Attachment A – List of Affected FSAR Sections

Attachment B - SGTR Figures

Attachment C - FSAR Addendum Markups

CALLAWAY PLANT
FIGURE 15.6-33D
REACTOR COOLANT SYSTEM AND STEAM GENERATOR (RUPTURED AND INTACT GENERATORS) WATER MASS TRANSIENT FOR SGTR EVENT WITH OVERFILL
REV. 16 5/11

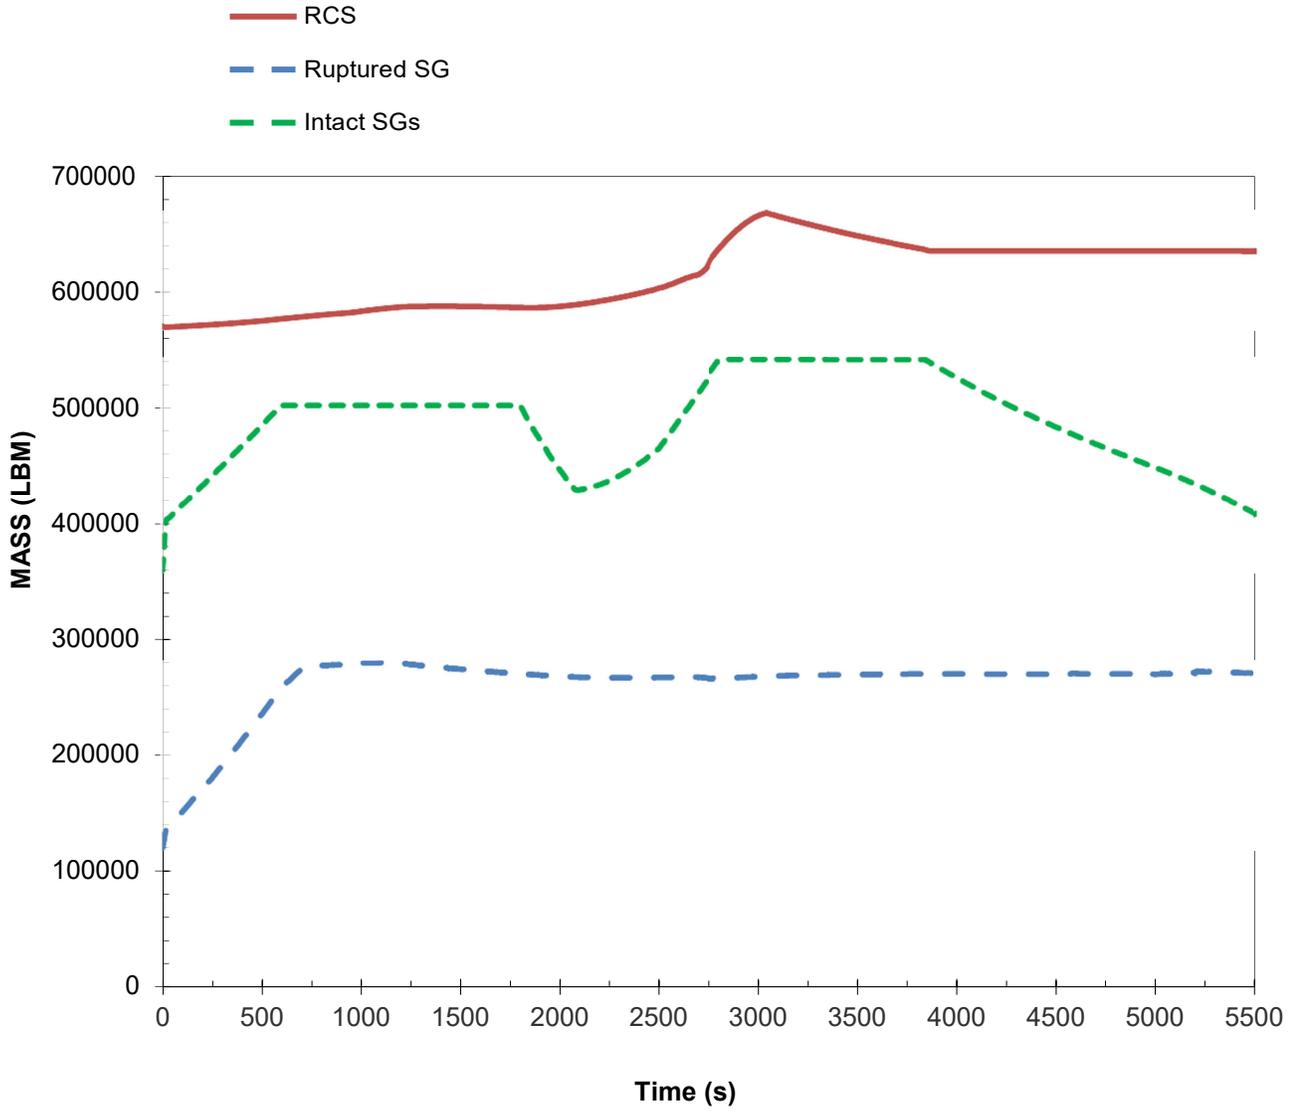
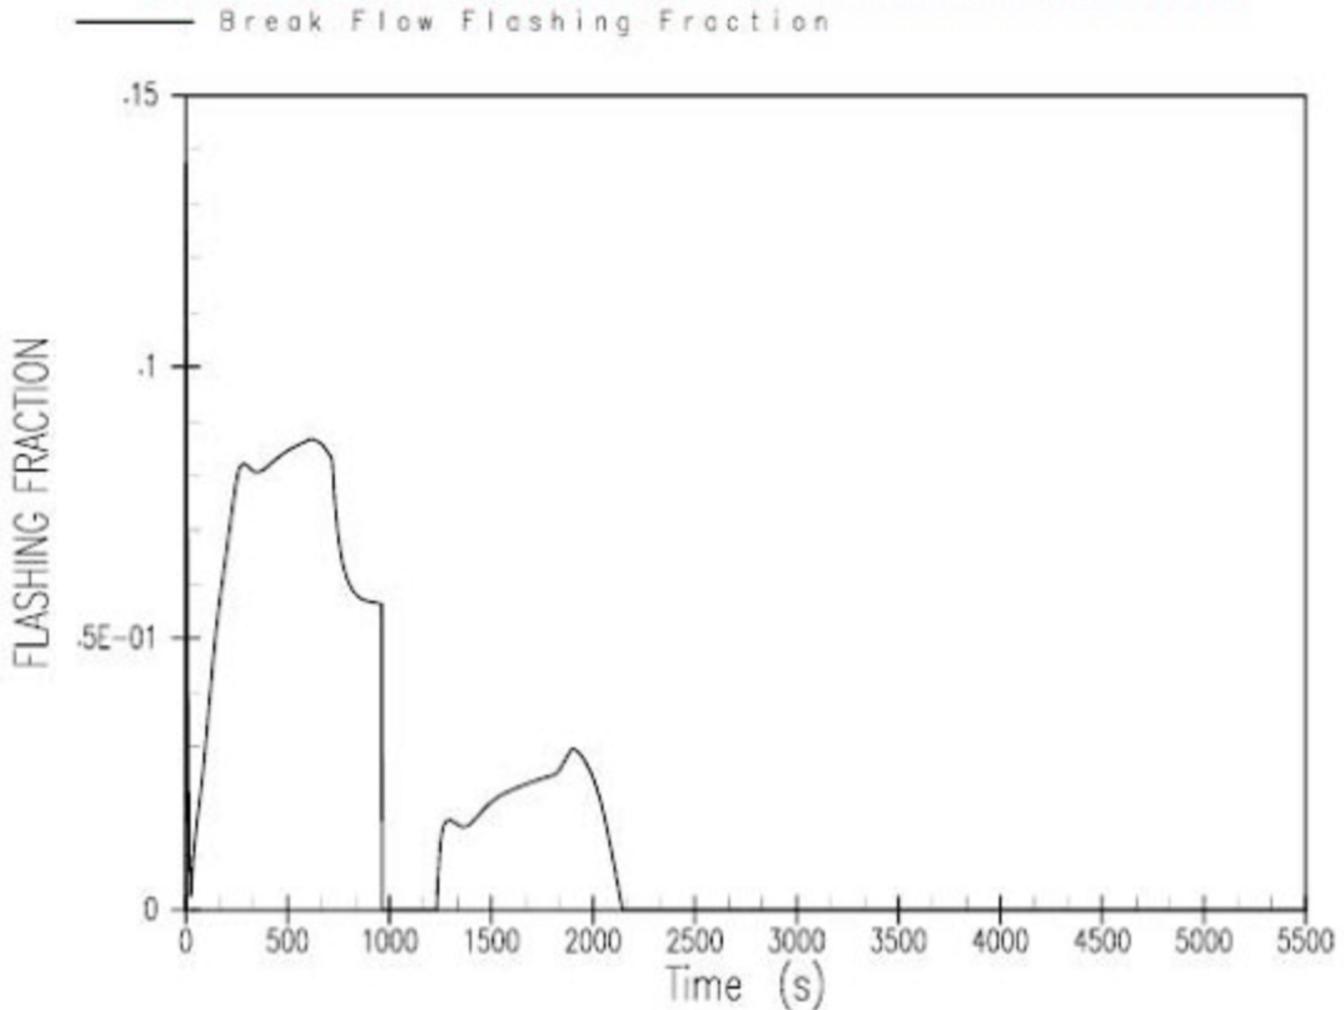
l. The reactor coolant system, ruptured steam generator and intact steam generators' masses are modeled using the RETRAN analysis results from Figure 15.6-33d. This is consistent with the analysis approved in Reference 3. The analysis presented in the Section 15.6.3.1.3 modeled conservative bounding values for the RCS and secondary masses.

Replace with graph on Tab E from spreadsheet "Overfill_FSAR_Plots.xlsx"

Figure 15.6-33d: Replaced with Tab D in spreadsheet "Overfill_FSAR_Plots.xlsx"

FIGURE 15.8-33E

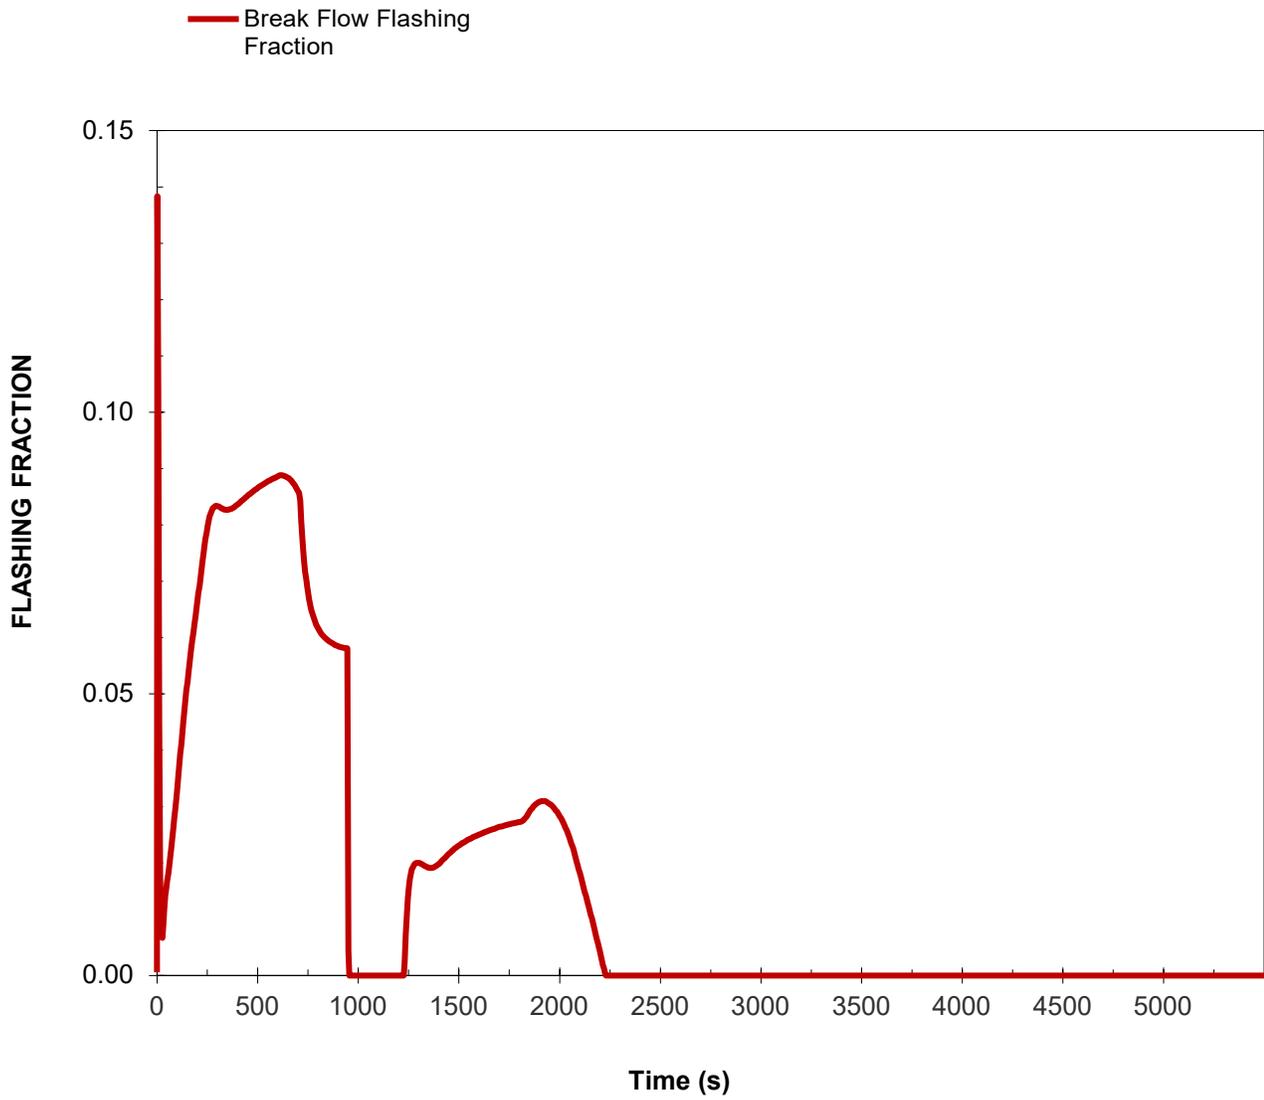
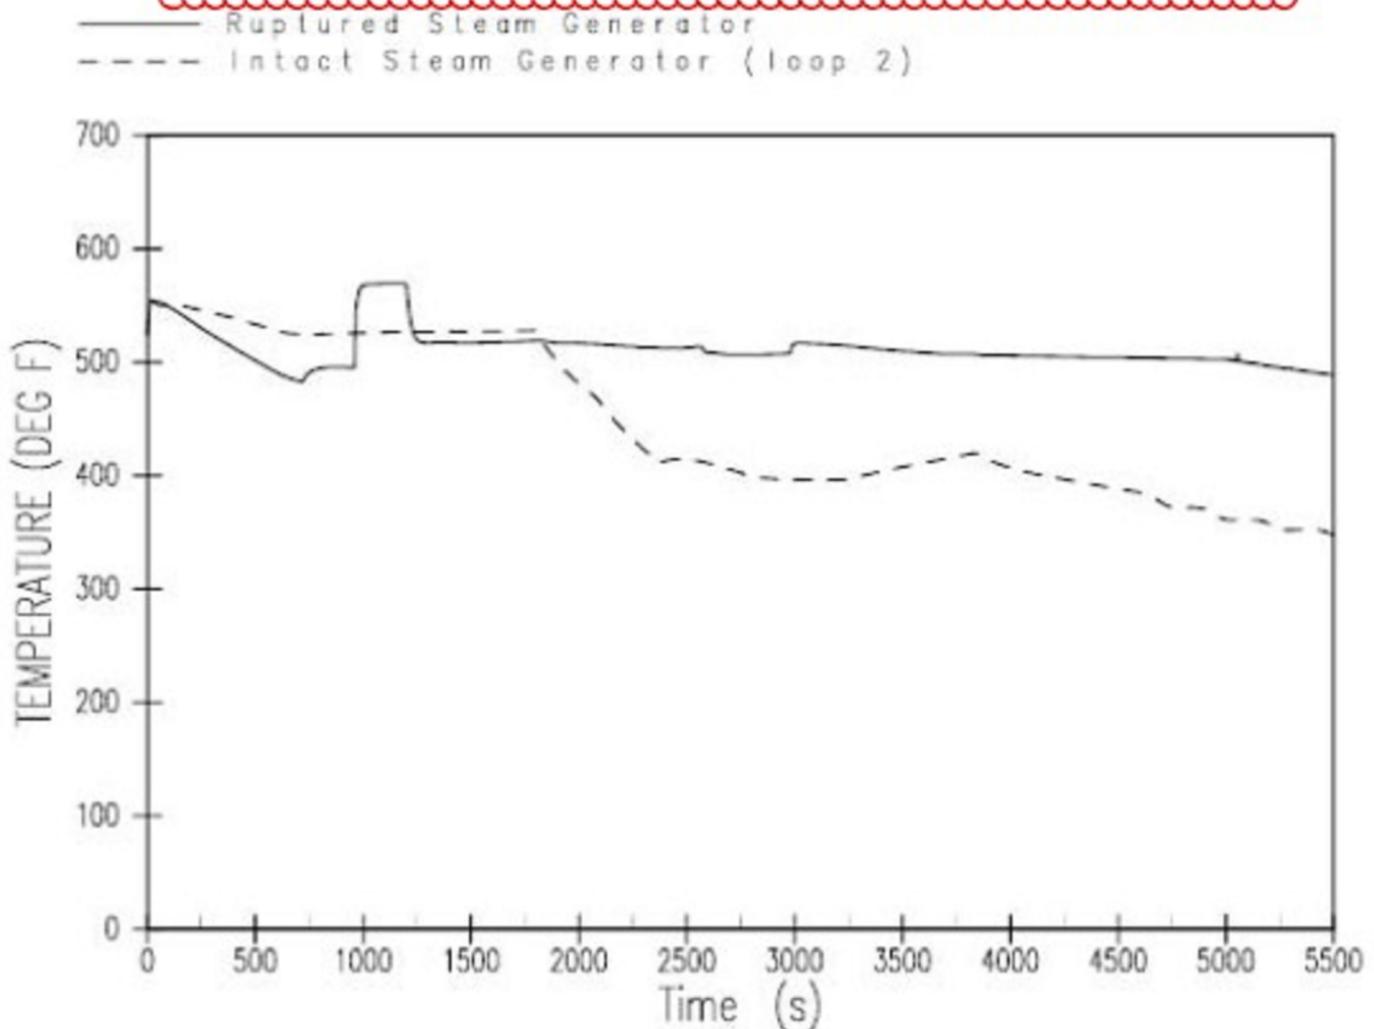
- The Section 15.6.3.1.3 dose analysis modeled conservative bounding values for the flashing fraction. For the analysis of doses for the overfill case the transient flashing fraction from the RETRAN analysis presented in Figure 15.6-33e ~~is used. This is consistent with the analysis approved in Reference 3. This analysis models the release of all the activity contained in the flashed break flow. This conservative assumption is consistent with Section 15.6.3.1.3 which modeled the direct release of activity in flashed break flow even after the ruptured SG's failed open atmospheric steam dump (ASD) valve was isolated.~~

Replace with graph on Tab F from spreadsheet "Overfill_FSAR_Plots.xlsx"

Figure 15.6-33e: Replaced with Tab E in spreadsheet "Overfill_FSAR_Plots.xlsx"

FIGURE 15.6-33Q

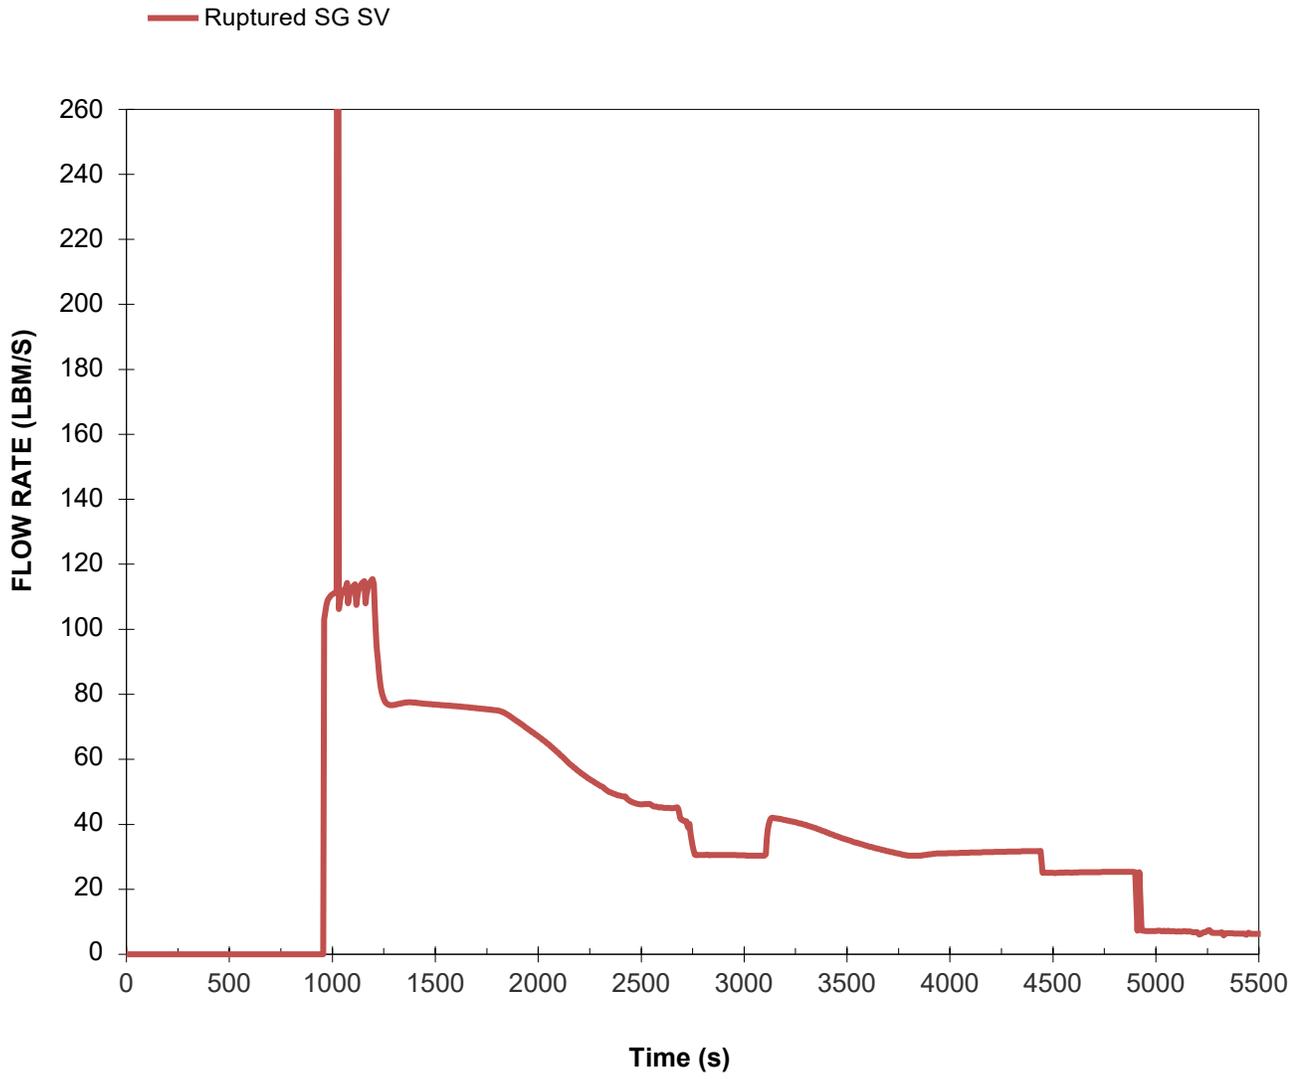
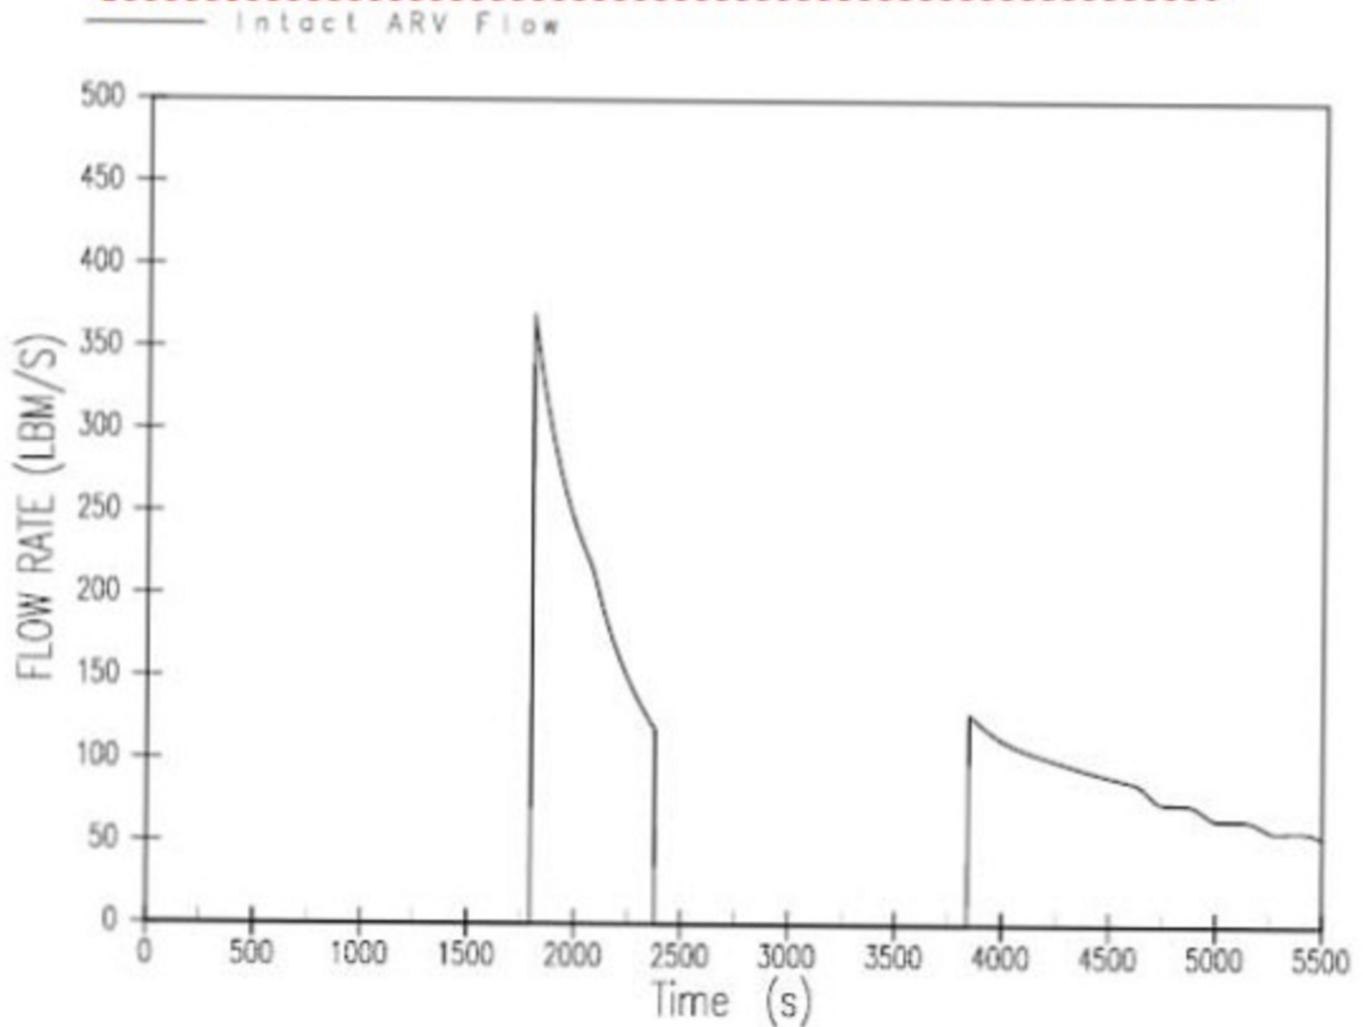
j. The ruptured SG releases are modeled using the RETRAN analysis results presented in Figure 15.6-33g. ~~In the calculation of doses for the cooldown to RHR conditions it is assumed that a steam flow rate of 8 lbm/sec is maintained due to the failed open safety valve. Thus, 144,000 lbm of steam is released from the ruptured SG in the 5 hours from break flow termination until RHR cut-in.~~ The total steam released from the ruptured SG is 292,353 lbm over 9.4 hours.

Replace with graph on Tab H from spreadsheet "Overfill_FSAR_Plots.xlsx"

Figure 15.6-33g: Replaced with Tab G in spreadsheet "Overfill_FSAR_Plots.xlsx"
